Product Change Notification: SYST-17HGRB251

dsPIC33AK256MPS306 Family Silicon Errata and Data Sheet Clarification

Added data sheet clarifications 1. Module: 40 MSPS Analog-to-Digital Converter (ADC) and 2. Module: I/O Ports with Edge Detect. Updates to workaround code in 10. Module: CPU.

Figure 1. Example of Incorrect DEVID from MPLAB X IDE

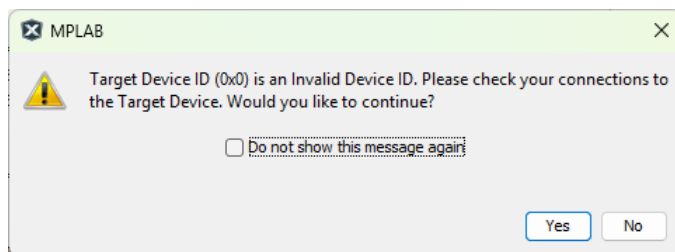
If the power monitor module is enabled via the FPWRM configuration bit, during device programming/ICSP entry, the power monitor may trigger a reset event during the loading of the configuration fuses, and as a result, an incorrect DEVID message may appear.

Select **Yes** in the message prompt or the equivalent of 'Yes' in the programming environment, and the device will program as expected.
